BUSINESS CREATION UNIT AUDIO

SERVICE NEWSLETTER

08.01 TYPENUMBER(S): **AZ1030, AZ1035, AZ1040, AZ1045, AZ1120, AZ1550, AZ1560, AZ1565, AZ2000, AZ2010, AZ2020, AZ2025**

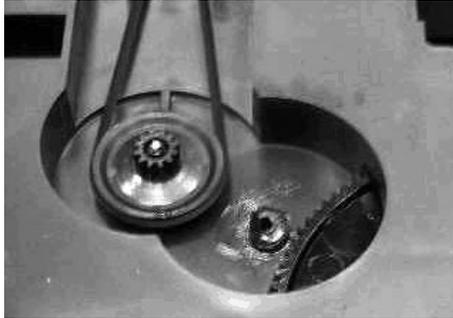
INFORMATION : In order to solve accidental mute problems on /01, /11 and /16 versions, the AF & POWER BOARD has been modified.
For servicing the new AF & POWER BOARD assembly refer to Service Information A00-561 (3140 785 22560).

REMARKS : New AF & POWER BOARD assemblies are used in production from week 0037 onwards.

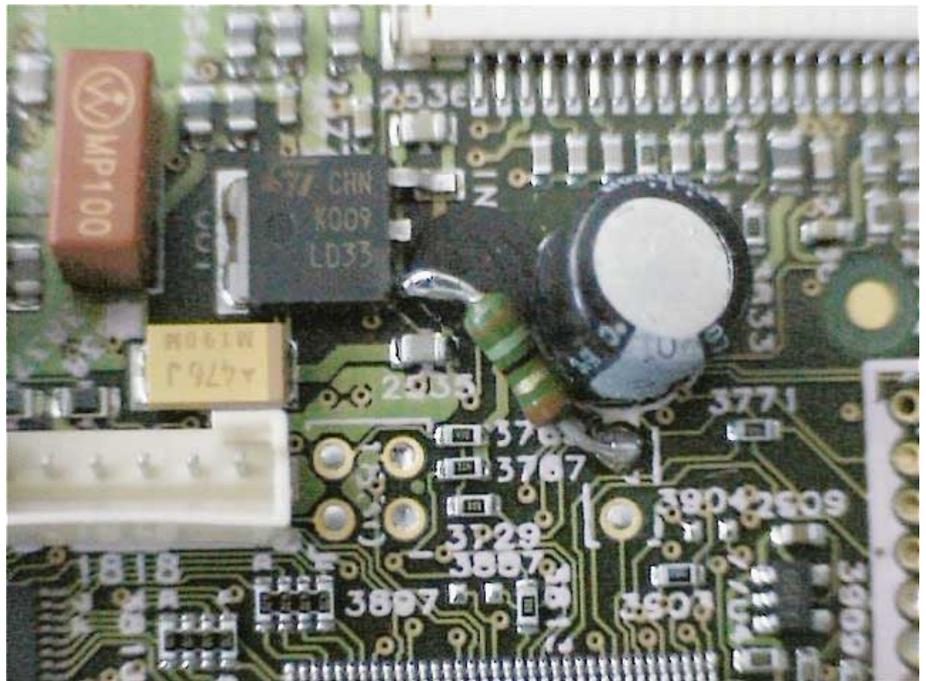
Clock jitter in DASP-IC item 7701 on CDR Mainboard can result in hang-up of the microprocessor. After Power off, Power on the set will normally start but the phenomenon might return again.

CURE : To solve this problem in running production and as service solution, the power supply of D3V3 has been improved by adding a resistor of 27Ω (CRB 1/6W A PM5 and codenumber 4822 116 52188) between "disconnected" pin 1 of item 7535 and ground (hole 2 of item 1701).

See part of the main board (top side view) for location of the resistor.

REMARKS : With release of the A9 version of CDR Mainboard this resistor is implemented in printed board layout and mounted in production.

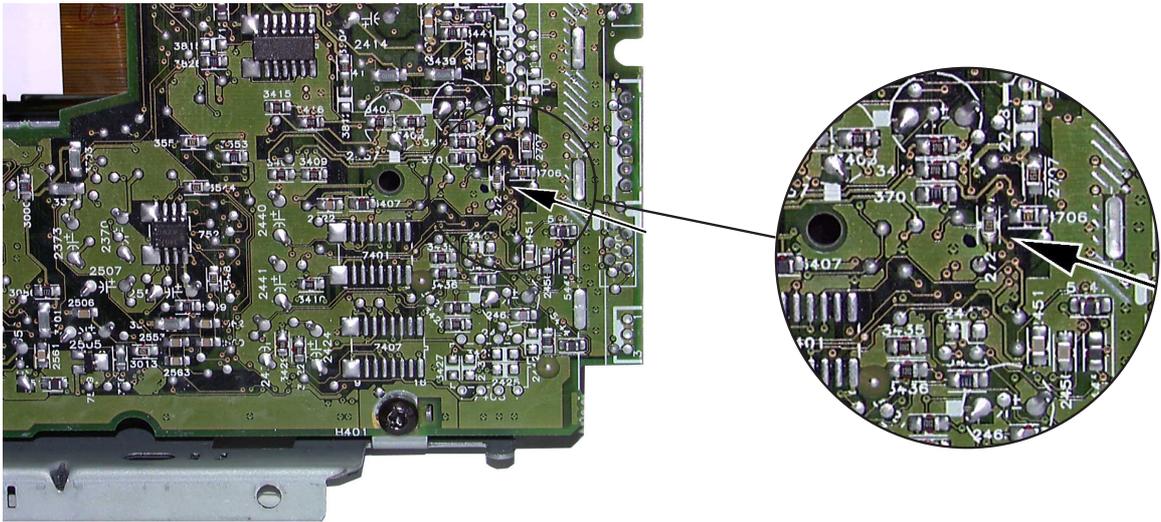
When source "AUX DIGITAL" is selected and no source is connected or it is switched off, there is a burst of noise audible through the speakers every 3 seconds. If a digital source is connected and switched on, the noise disappears.

- CURE :
- change SMD resistor
3300 on Interface Board (CDR785, CDR786) resp.
3358 on Digital Switch Board (FW-R7, FW-R8)
to 6.8k Ω (4822 117 11507)
 - add resistor 2721 (6.8k Ω 4822 117 11507) on the bottom side of CDR Main Board → see picture below

REMARKS : This solution will also be implemented in production as a running change.

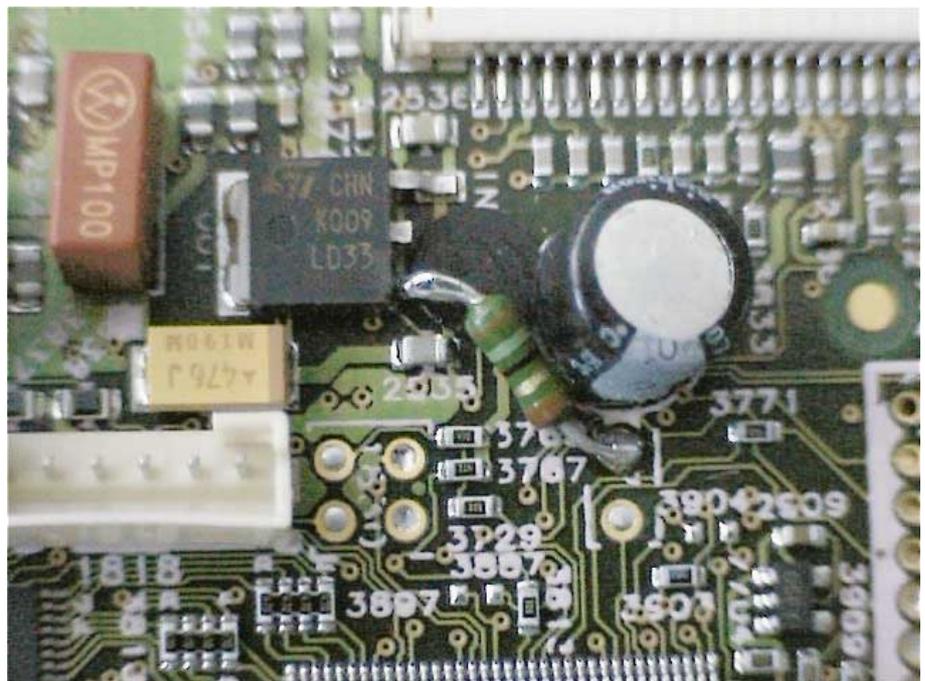
SYMPTOM : **IRIS CODE C 5 6 1**
The CD-Recorder does not recognize the Philips HR100 CDR ("No disc" is shown on the display).

CURE : The problem can be solved by the following hardware and software modification:

1. Hardware modification at the topside of the Main Board
 - Change capacitor 2322 from 3.3nF to 1.5nF (4822 126 14247)

2. Software modification at the topside of the Main Board
 - Update software version of item 7208 (in socket) to version 92.01. Programmed flash with version 92.01 or higher can be ordered with codenumber 3104 123 94850.
 - Update software version of item 7703 (soldered) to version 1.51. Programmed flash with version 1.51 or higher can be ordered with codenumber 3104 123 85760.

REMARKS : Software versions lower than 1.43 & 91.91 which have been updated to the latest version **must always be re-adjusted with the COMPAIR Tool**. Workshops which do not use COMPAIR have to replace these 3rd generation CDR-modules. See also Service Newsletter SNL2000.07.08.

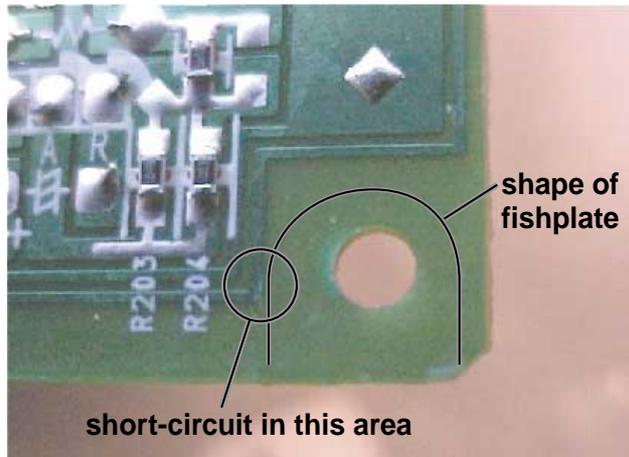
- SYMPTOM** : **IRIS CODE 1 1 1 X**
The Standby-LED is inoperative.
The power consumption in standby is higher than specified and close to the power consumption in STOP-mode.
- CURE** : The problem is caused by the fishplate supporting the Power Supply Unit. In some cases the fishplate can touch a copper track of the Power Board close to resistor R204 (see picture below).

This will short-circuit parts of the power supply circuitry to the ground potential of the bottom frame.
As a result, the display will switch off, but the LED does not light.

Solution: Place an insulating layer (i.e. friction tape or piece of Fuller board) between printed board and holder.

- REMARKS** : The green protection lacquer on the printed board normally ensures proper insulation of copper tracks. However, due to transportation or rough handling, the critical area can get exposed.
- In production, the bottom frame has been modified.
The modified parts are used from week 0020.4 onwards.

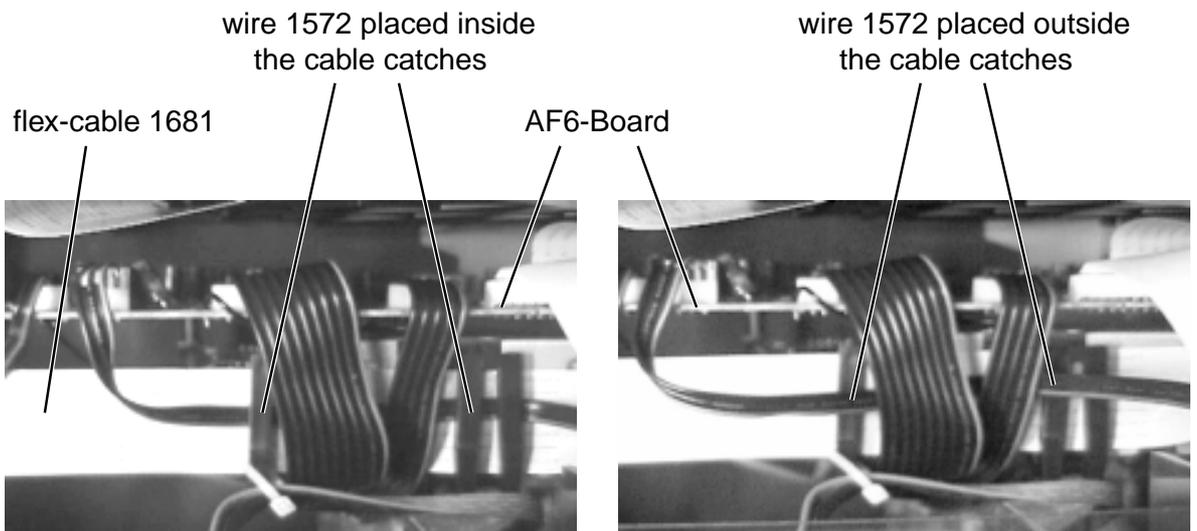
SYMPTOM : **IRIS CODE 1 5 4 4**
Ticking sound (similar to that of a clock) is audible from the center speaker during quiet portions of music.

CURE : The problem is caused by crosstalk from flex-cable 1681 to wire 1572.
The problem can be solved by routing wire 1572 outside the wire catches of flex-cable 1572 as shown in the right picture below.

Portion of Main Board (top side) for location of 2335 / 3337

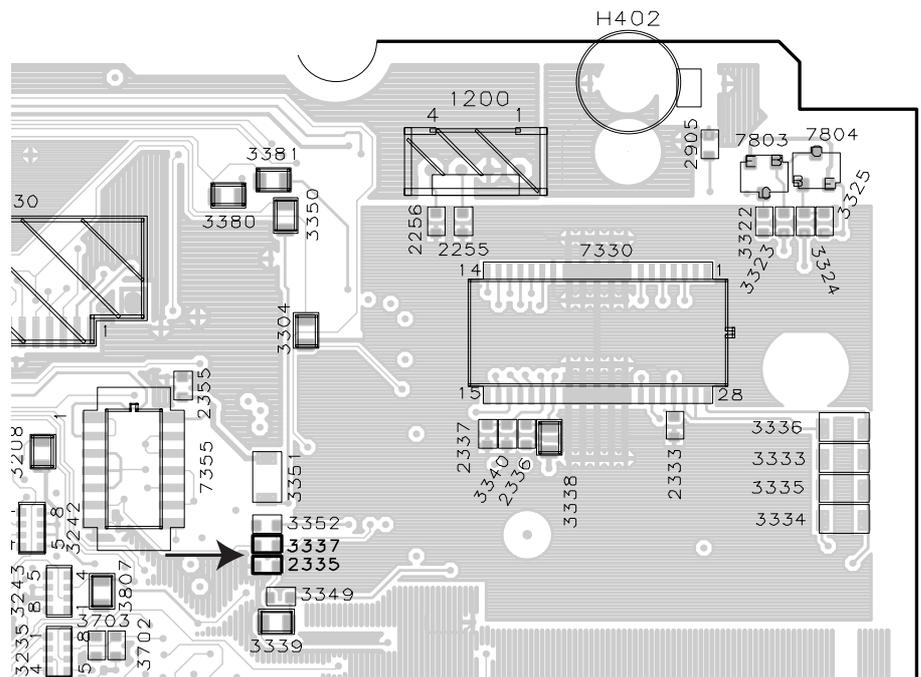
SYMPTOM : **IRIS CODE 1 5 6 X**
Stops during recording
Motor noise while recording CDR/W disc

CURE : Above problems can be solved by a hardware (1) and a software (2) modification. Note that both changes must be implemented at the same time.

1. Hardware modification at the topside of the main board
- Change item 2335 from 10nF to 47nF (3198 017 34730)
 - Change item 3337 from 68kΩ to 56kΩ (4822 051 30563)

Portion of Main board for location of flash memories 7208 / 7703

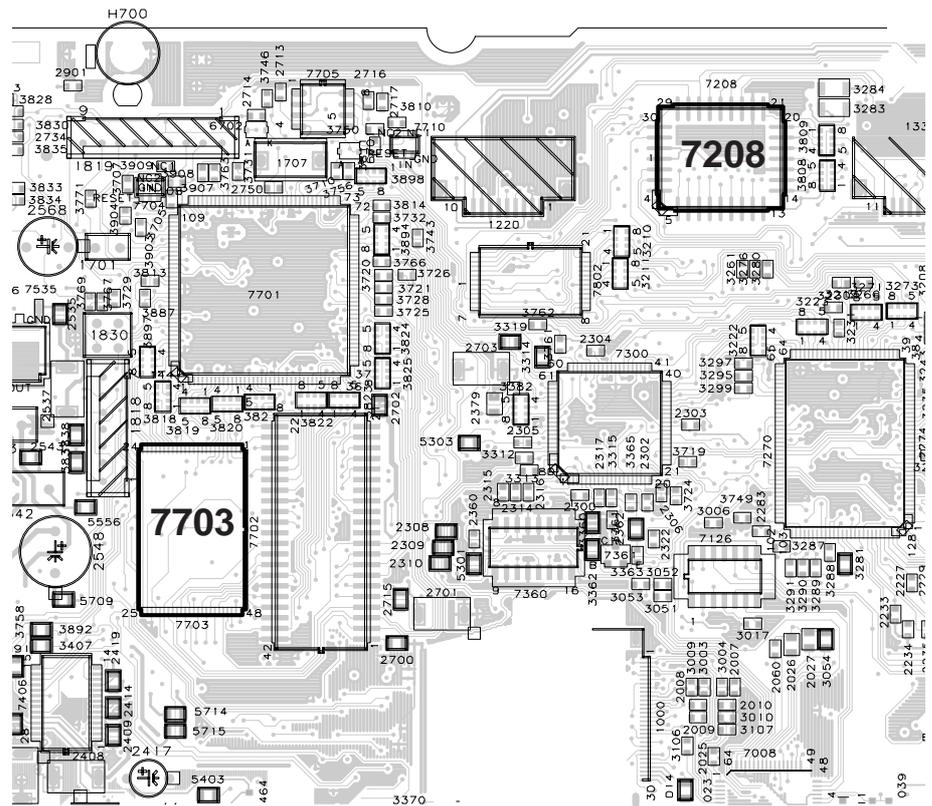
2. Software modification
- The software version of item 7208 at the topside (in socket) has to be changed to version 91.80 or higher.
Programmed flash memory with version 91.80 can be ordered with codenumber 3104 123 94850.
 - The software version of item 7703 at the top side (soldered) has to be changed to version R-1.34 or higher.
Programmed flash memory with version R-1.34 can be ordered with codenumber 3104 123 85760.

REMARKS : The status of the main-board can be identified by the board label.
 For board label F and lower : change 2335/3337, replace 7208/7703
 For board label G : change 3337, replace 7208/7703
 For board label H : replace 7208/7703
 For board label I : no changes necessary

Figure 2. Location of the ribs for rework

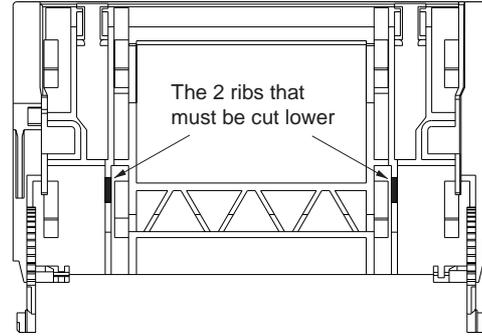
- 1) Cutting 2 ribs (both sides) on the cassette door in order to enable a bigger rotational movement for the door during eject (see figure 2 & 3).
- 2) Increasing the spring force on the cassette by pulling the spring in the direction and up to the level shown in figure 3.

Portion of the Front Circuit

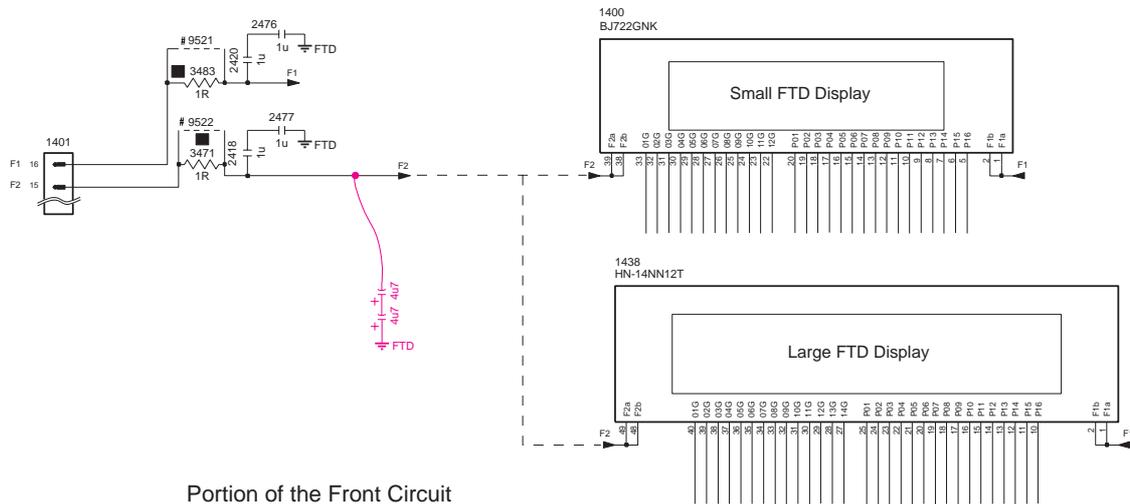
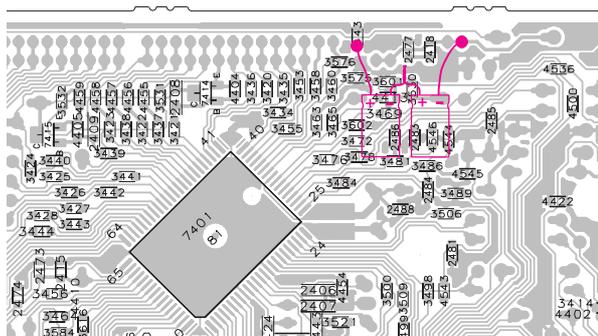
SYMPTOM : **IRIS CODE 1 1 4 X**
 A high frequency pitch (around 4kHz - 5kHz) is audible from the front display panel in quiet environment.

CURE : The source of the noise comes from the filtering SMD capacitors 2418, 2420, 2476 and 2477.
 The problem is resolved by adding 2 elcaps of 4,7 μ F (4822 124 40769) in series across the existing SMDs capacitors of the -F2 supply line.
 The elcaps can be soldered onto the copper side of the Front board as indicated in the circuit and SMD layout view below.

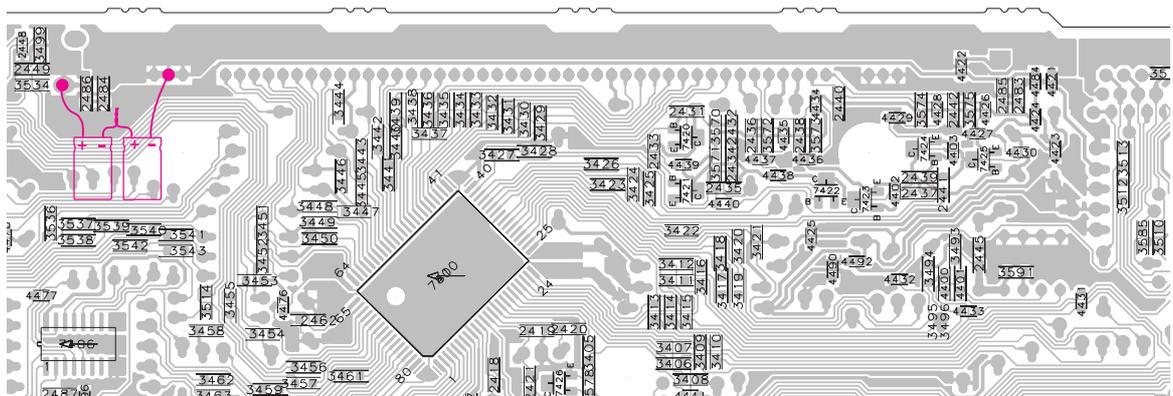
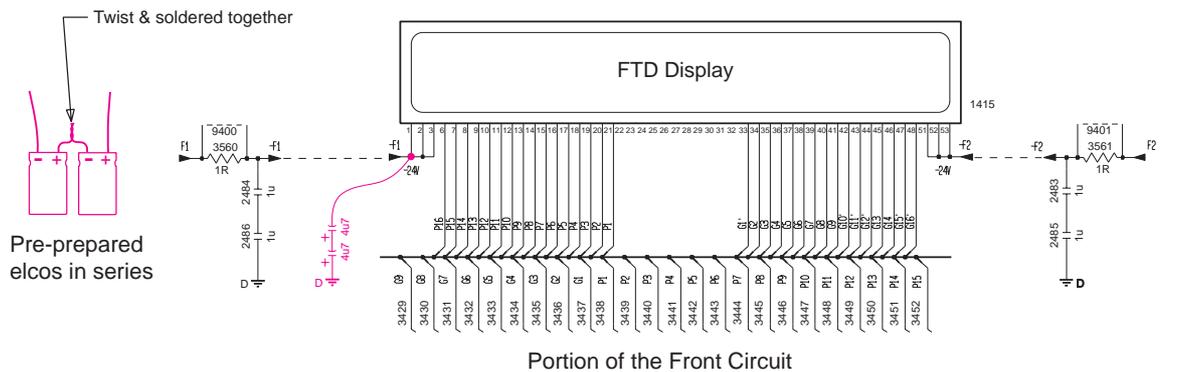
SYMPTOM : IRIS CODE 1 1 4 X

A high frequency pitch (around 4kHz - 5kHz) is audible from the front display panel in quiet environment.

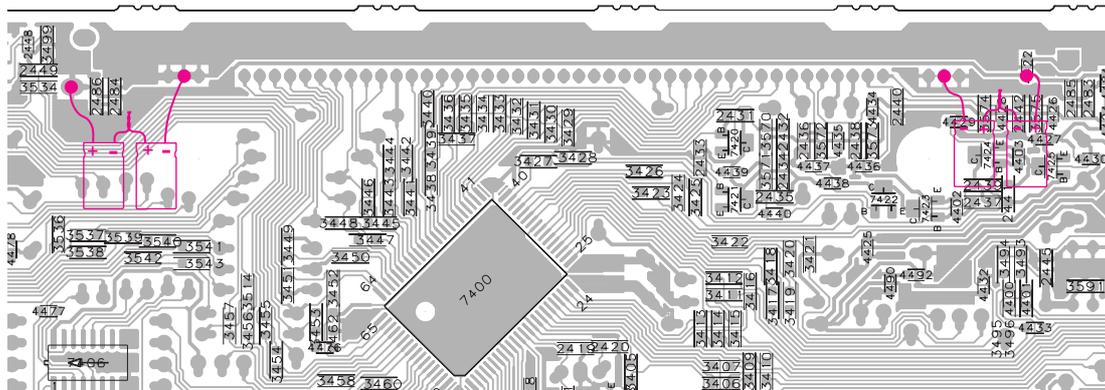
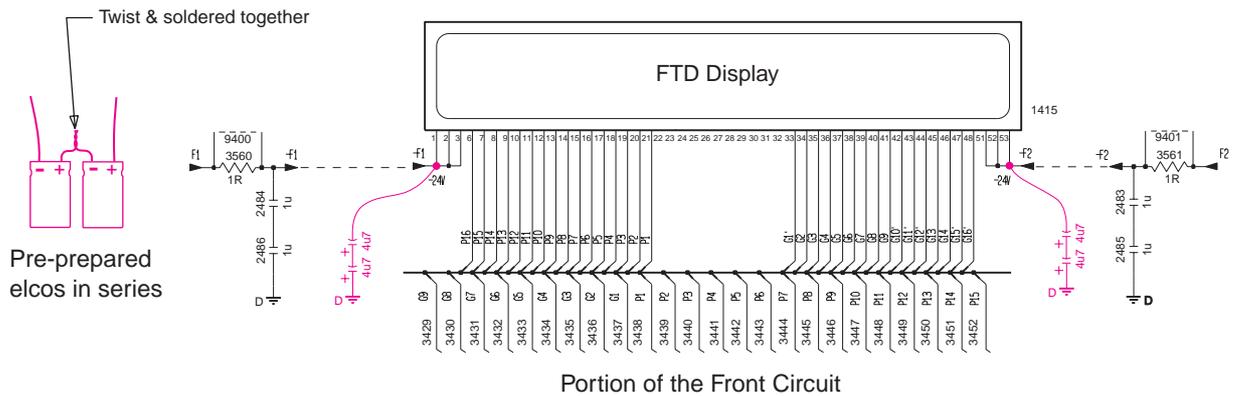
SYMPTOM : **IRIS CODE 1 1 4 X**
 Digital hum (whistling tone) is audible from the display in quiet environment.

CURE : The source of the noise comes from the filtering SMD capacitors 2483 - 2486 for the FTD display supply -F1 and -F2. The problem is resolved by adding 2 x 2 elcaps of 4,7 μ F (4822 124 40769) in series across the existing SMDs capacitors. The capacitors can be soldered onto the copper side of the Front board as indicated in the circuit and SMD layout view below.
